Response to Submissions Report - August 2015

**Kembla Grange Resource Recovery Facility
Building Material Storage and
Resource Recovery Facility Exceeding 30,000 Tonnes per Annum and
Redesign and Expansion of Approved Facility**

**Lot 10 DP 878167
50 Wyllie Road, Kembla Grange
Application No. SSD-5300**

Prepared for Bicorp Pty Ltd

Figure 2: Predicted Maximum Cumulative PM₁₀ 24-hour Average Concentration (with mitigation) $\mu\text{g}/\text{m}^3$
Reference: Figure 14 of Revised Air Quality Assessment, GHD July 2015

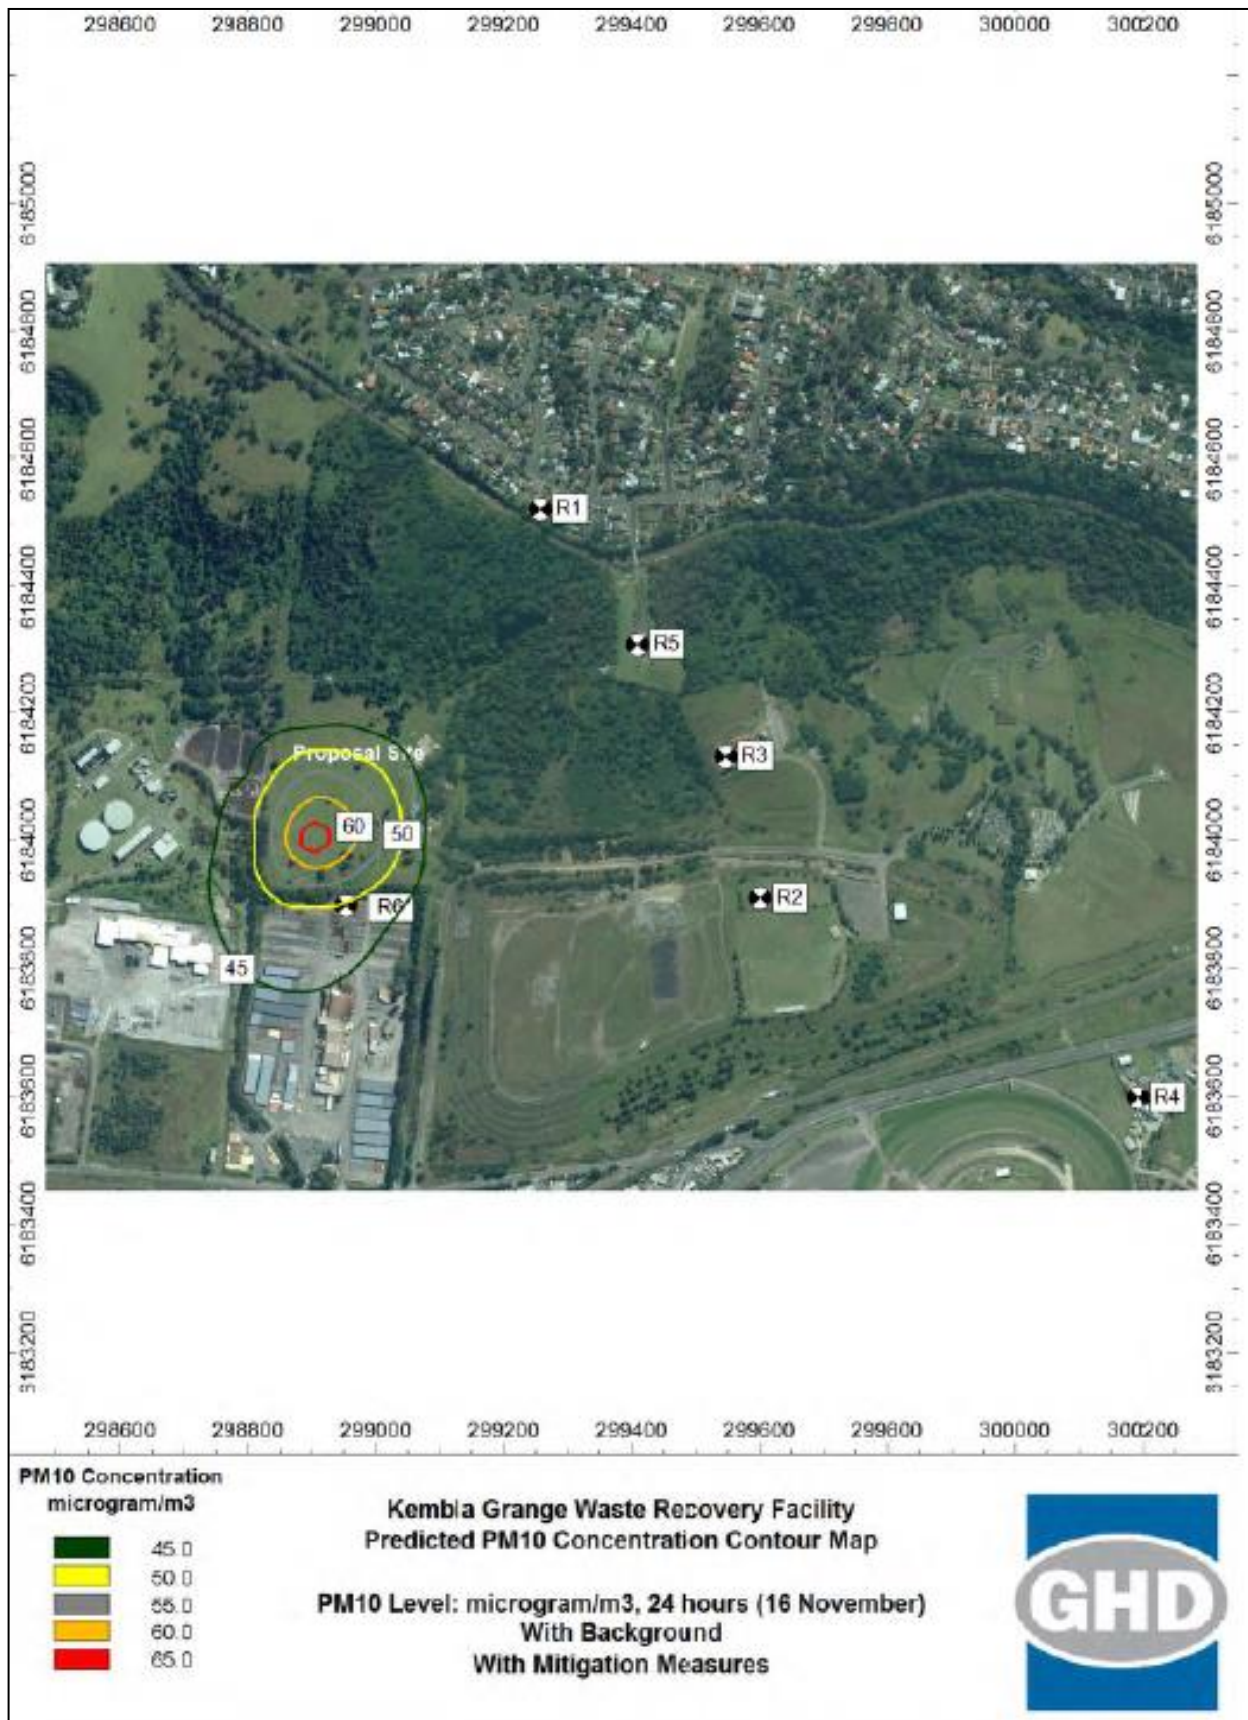
The borderline PM10 result is confirmed by Figure 15 of the GHD assessment "Predicted Cumulative PM10 24-hour Average Concentration (with mitigation) µg/m³" (included below). The location of the sensitive receiver "R6" appears to be located on the PM10 cumulative impact contour level 50µg/m³. This contour level defines the area of impact within which the PM10 impact criteria would be exceeded. Had the sensitive receiver R6 been located 10 metres further west or north, Figure 15 shows it is highly likely the criteria would be exceeded. GHD modelled a location on our northern boundary when predicting dust deposition impacts. Had GHD used the same "conservative" assumption for predicting PM10 impacts, it would have exceeded the criteria. We do not have confidence that the Air Quality Assessment's results are valid when the conclusions of the assessment appear to be highly sensitive to variations in the location and sensitive receiver.

Within the revised Air Quality Assessment prepared by GHD in July 2015 Receptor 6 has been moved to the northern boundary of the Patrick site for both the odour and dust assessments. This location has been chosen to take into account maximum odour impacts from the proposal, with the revised location now shown in all figures within the revised Air Quality Assessment (July 2015).

Figure 4: Predicted –Annual Dust Deposition (with mitigation) g/m²/month

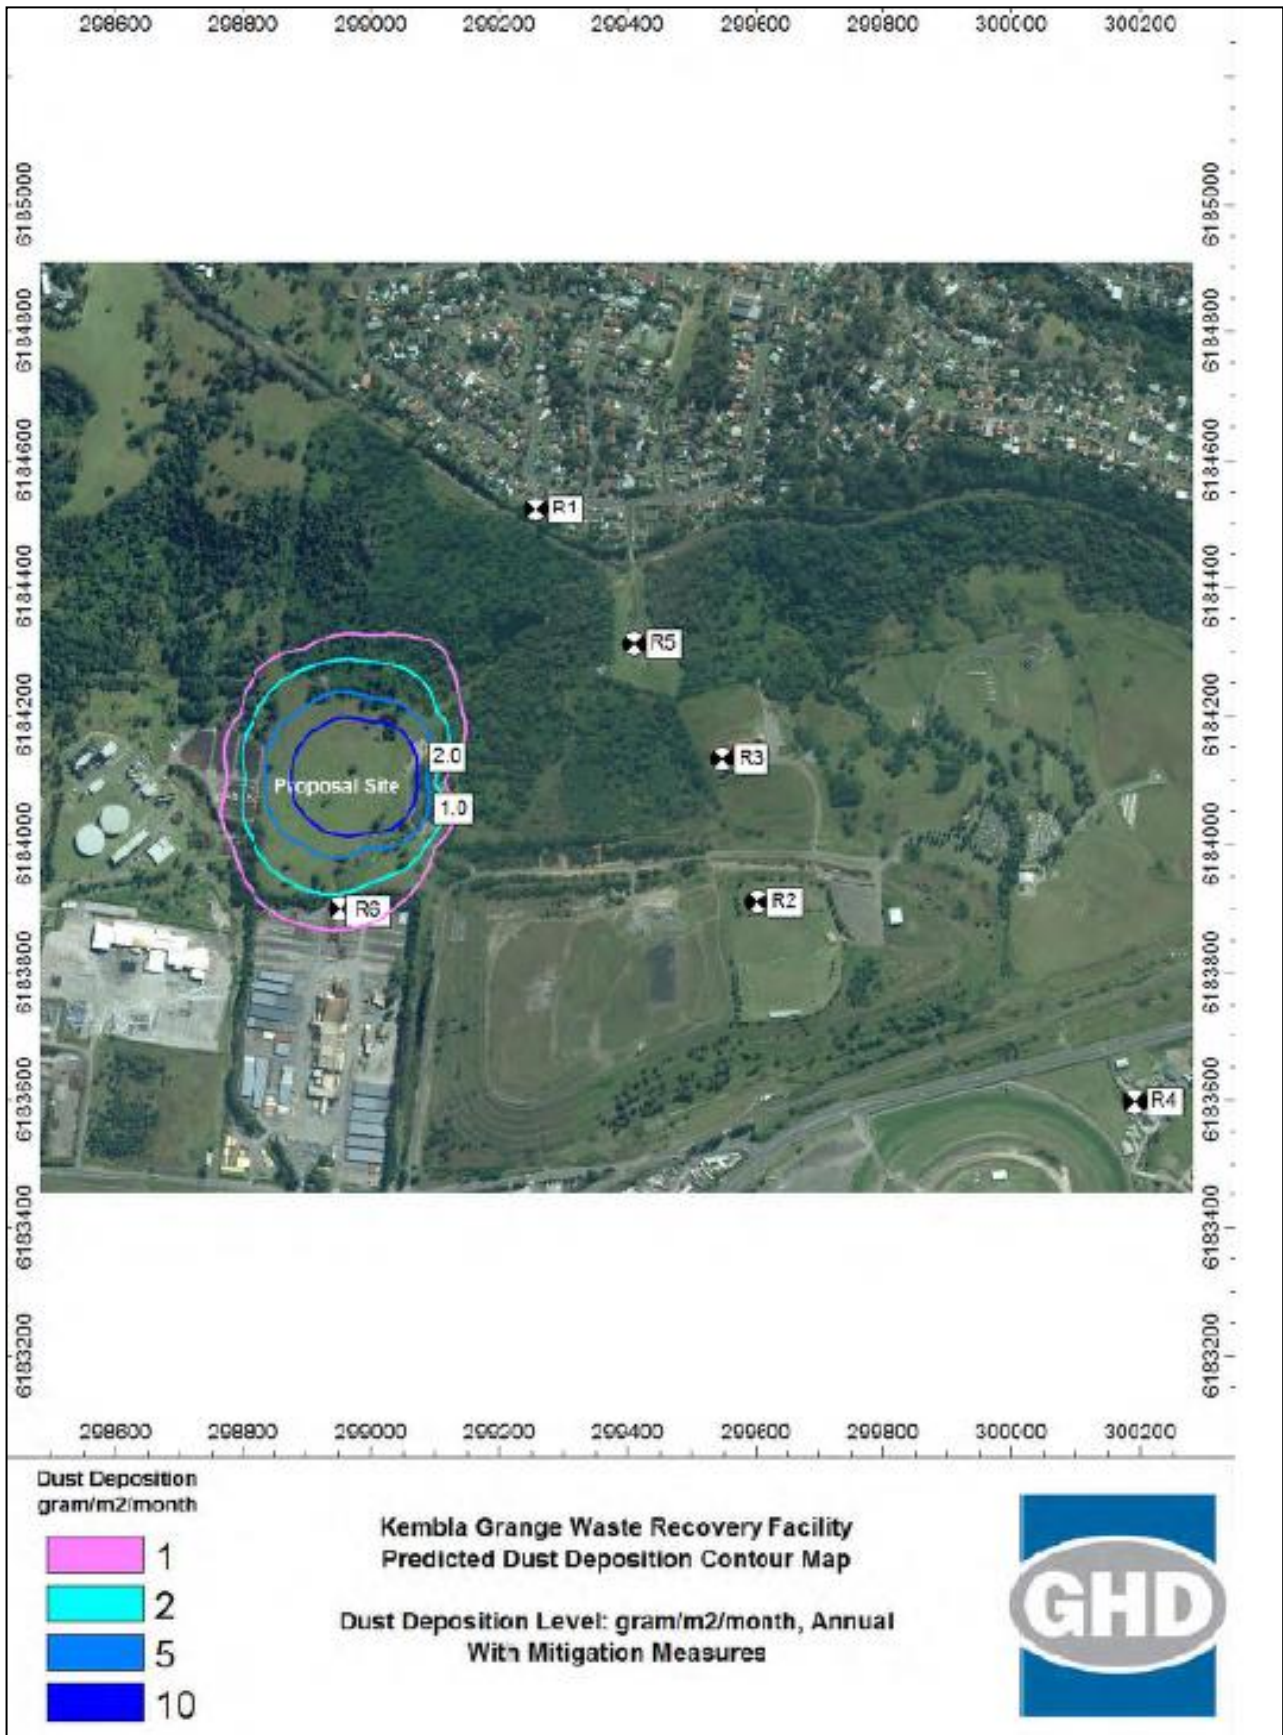
However Figure 17 of the GHD assessment "Predicted Annual dust deposition (with mitigation) g/m²/month" (included below) shows the location of the PAC Sensitive Receiver "R67" on the northern property boundary is not shown. To provide clarity the location of both receivers should be shown on Figure 17.
